**COMMENTS OF
WHITE PINE COUNTY, NEVADA
ON THE
DRAFT ENVIRONMENTAL IMPACT STATEMENT
FOR THE
CLARK, LINCOLN, AND WHITE PINE COUNTIES GROUNDWATER
DEVELOPMENT PROJECT**

Submitted: October 11, 2011

Figure 15: Drawdown for simulation of DEIS proposed action in model layer 2 after 75 years of pumping. The figure also shows pumping and monitoring well locations and the general outline of boundaries in the Myers (2011) model.

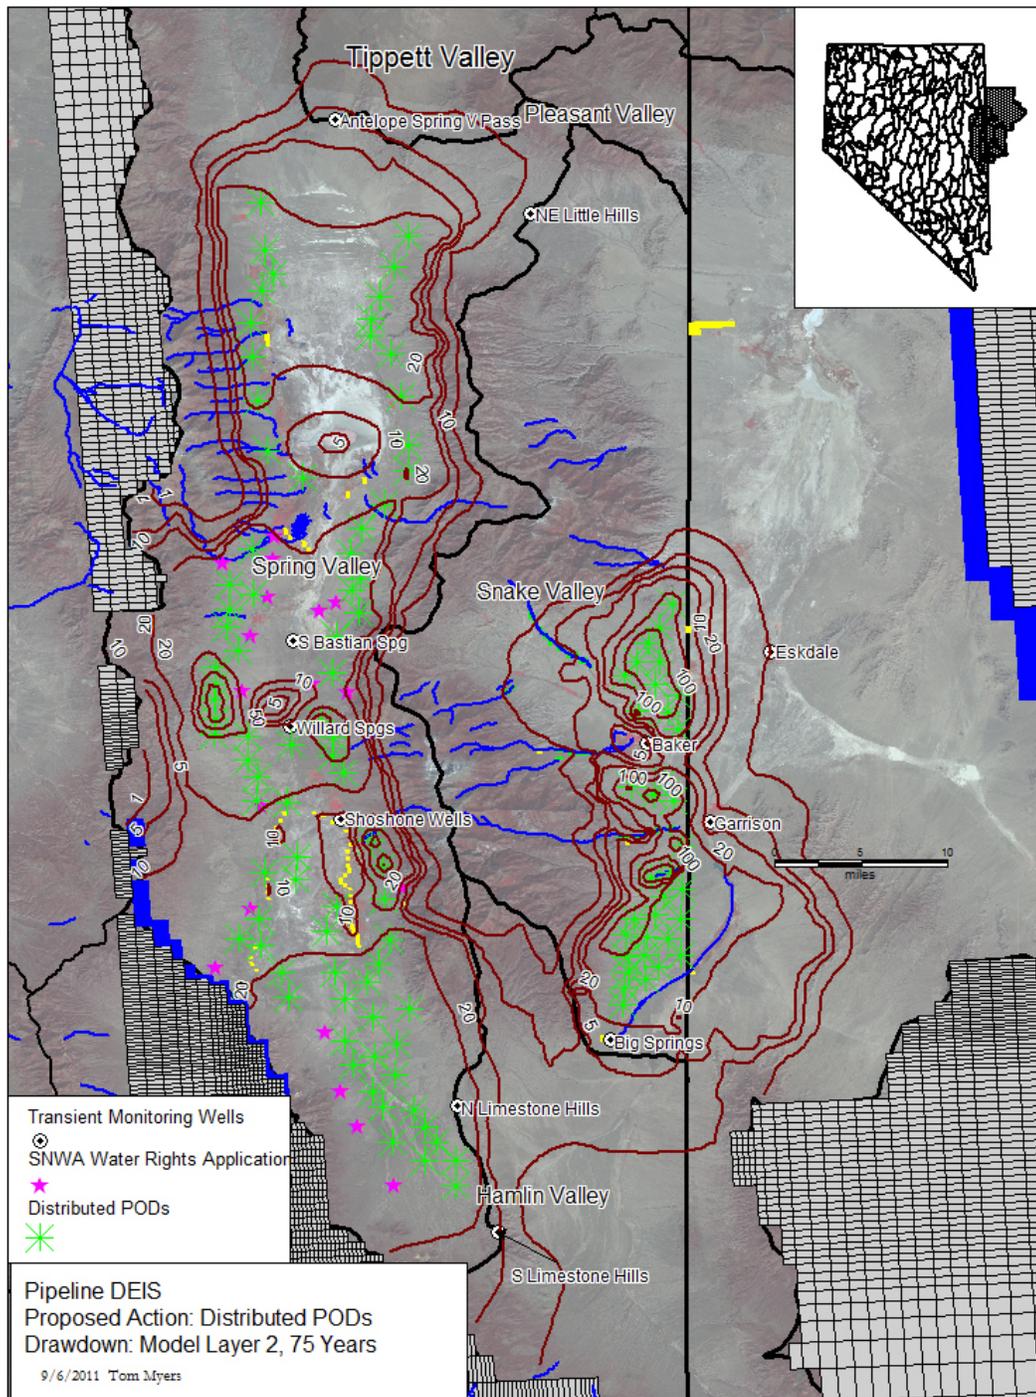
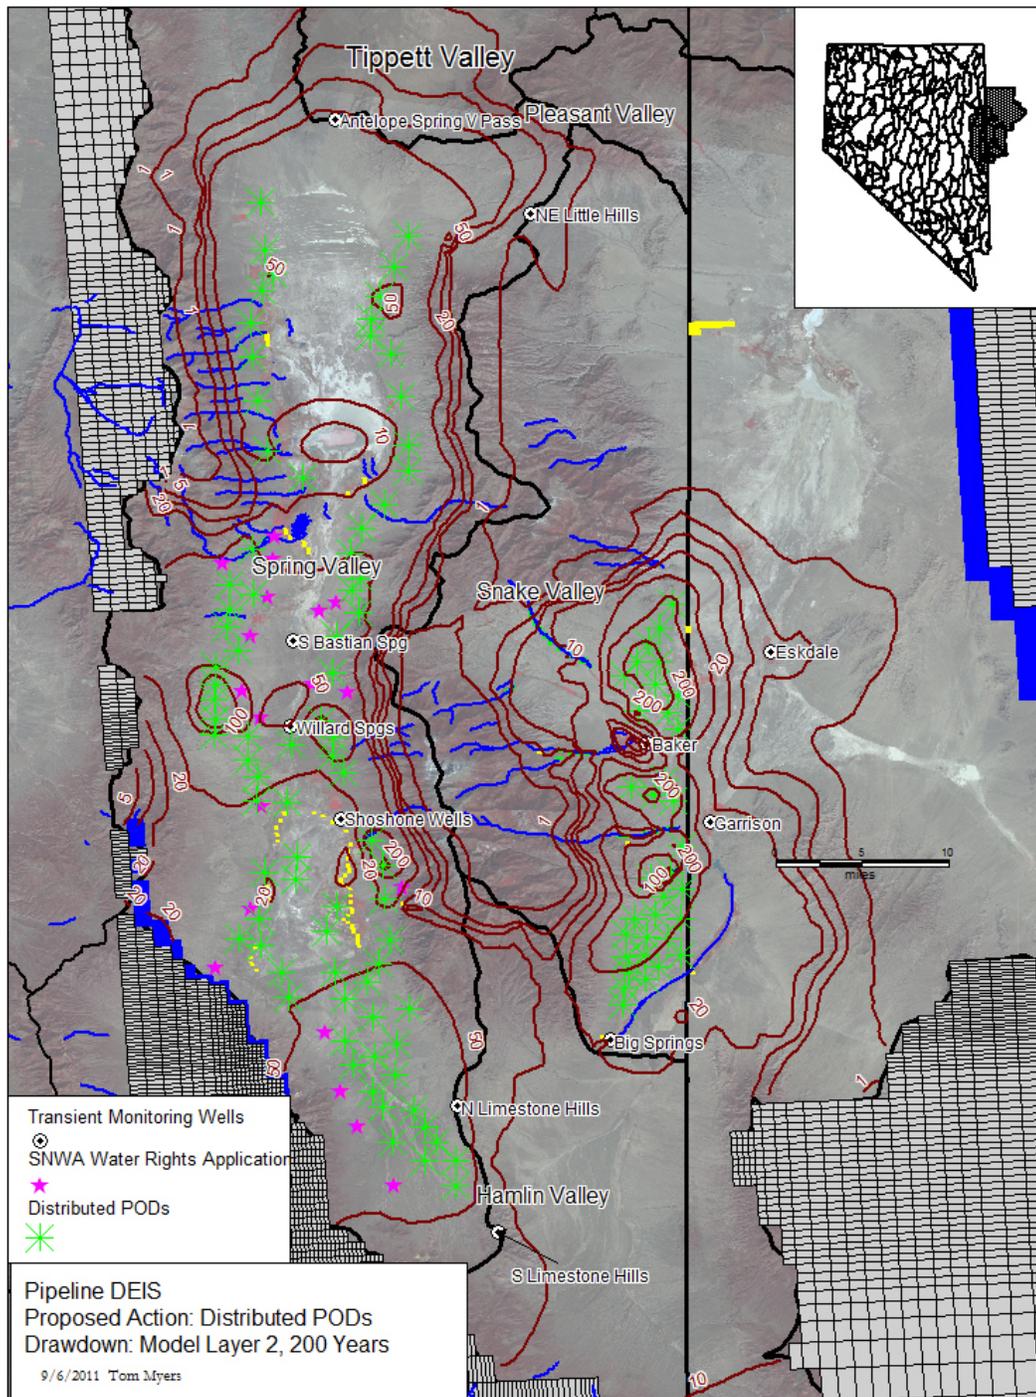
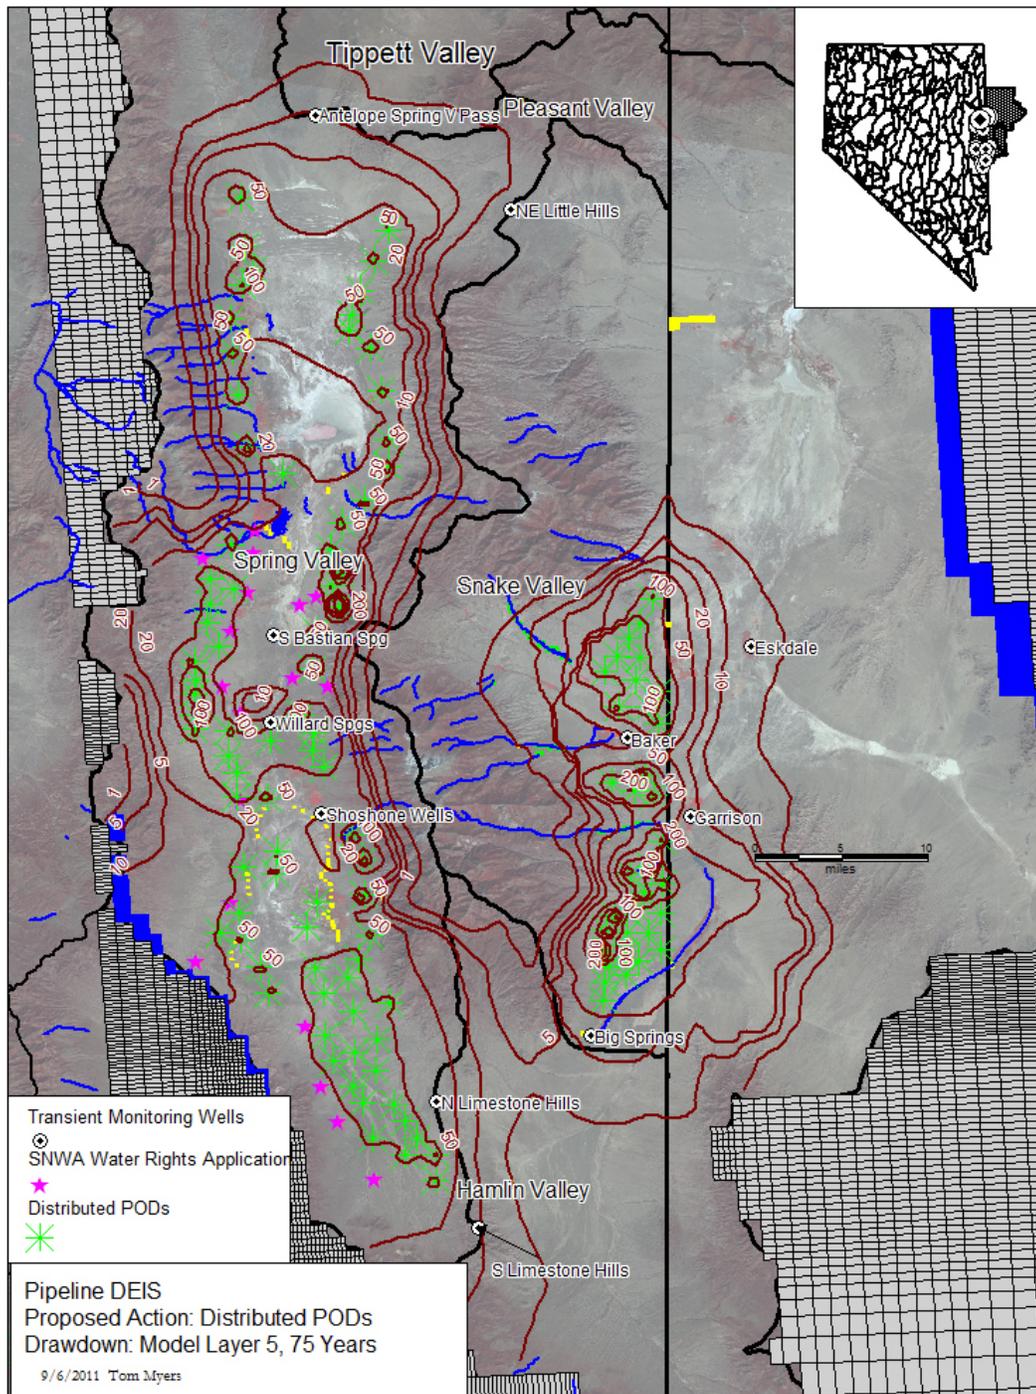
Drawdown predicted with the Myers model for the proposed action is similar in extent to that predicted by the DEIS, with several exceptions (Figures 15 through 18). First, the drawdown of course clusters around the pumping wells. However, the Myers model simulates numerous areas near those wells with drawdown in excess of 200 feet whereas the DEIS simulation does not (BLM, 2011, Figure 3.3.2-5). Only for pumping the full amount from the original locations does the DEIS predict drawdown near the wells to exceed 200 feet (BLM, 2011, Figure 3.3.2-18). There are even some small areas with drawdown exceeding 500 feet in layer 5 after 200 years (Figure 18).

The Myers model also predicts more drawdown in the middle of the north half of Spring Valley (Figures 15 through 18); the DEIS modeled drawdown did not exceed 10 feet under a broad section of the playa even after 200 years. The DEIS probably underestimated discharge reductions in this area. The reasons for the difference are probably SNWA's specific storage values being too high (releasing more water for a unit head drop).

Figure 23: Simulated proposed action flux values.

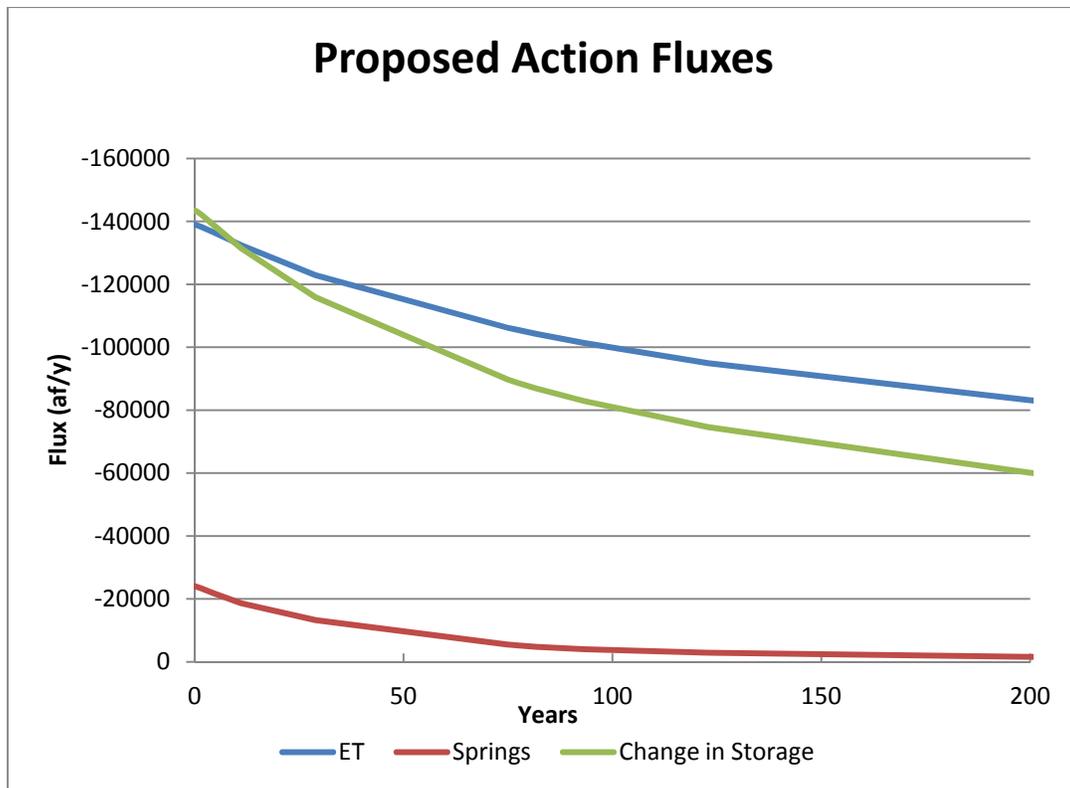
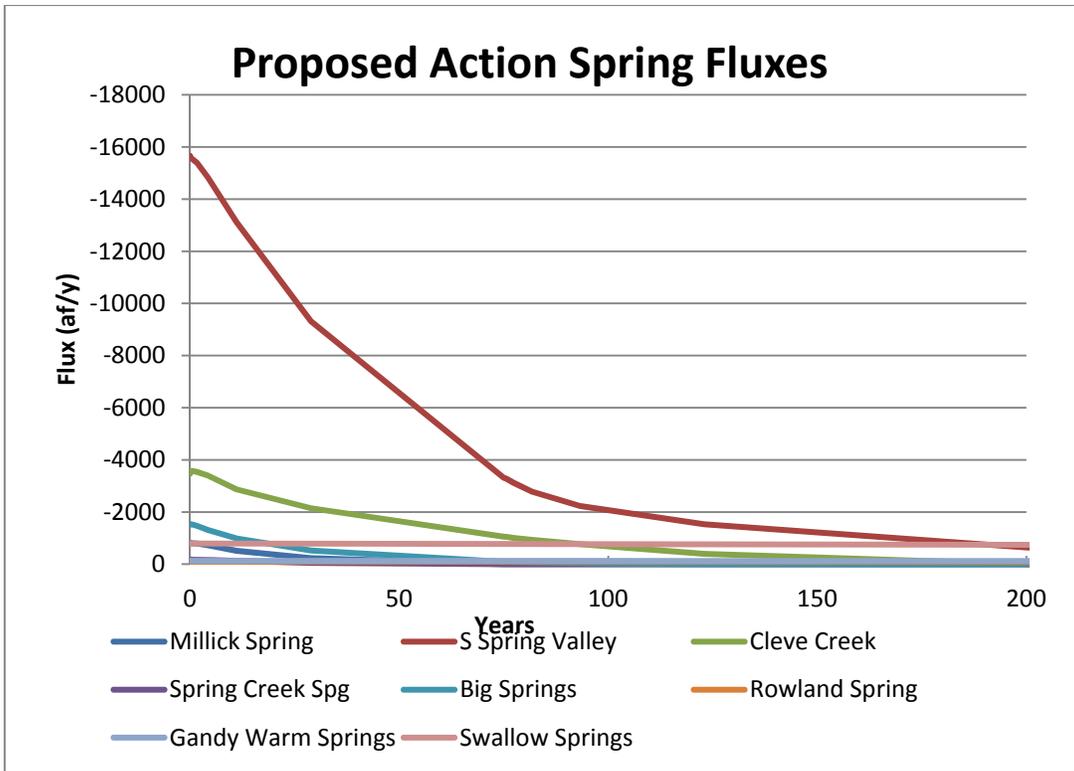
Pumping the DEIS proposed action causes most of the simulated spring flows to approach zero within 200 years (Figure 23). For example, Spring Creek and Millick Springs dry in 30 years, Big Springs in 80 years, Stateline Springs in 11 years, and discharge to Cleve Creek ceases in 120 years (Figure 24); Swallow Springs are relatively protected by the mountain-front normal fault. Flow from Steptoe Valley to Spring Valley increased by 3000 af/y within 200 years and by 10,000 af/y after 10,200 years.
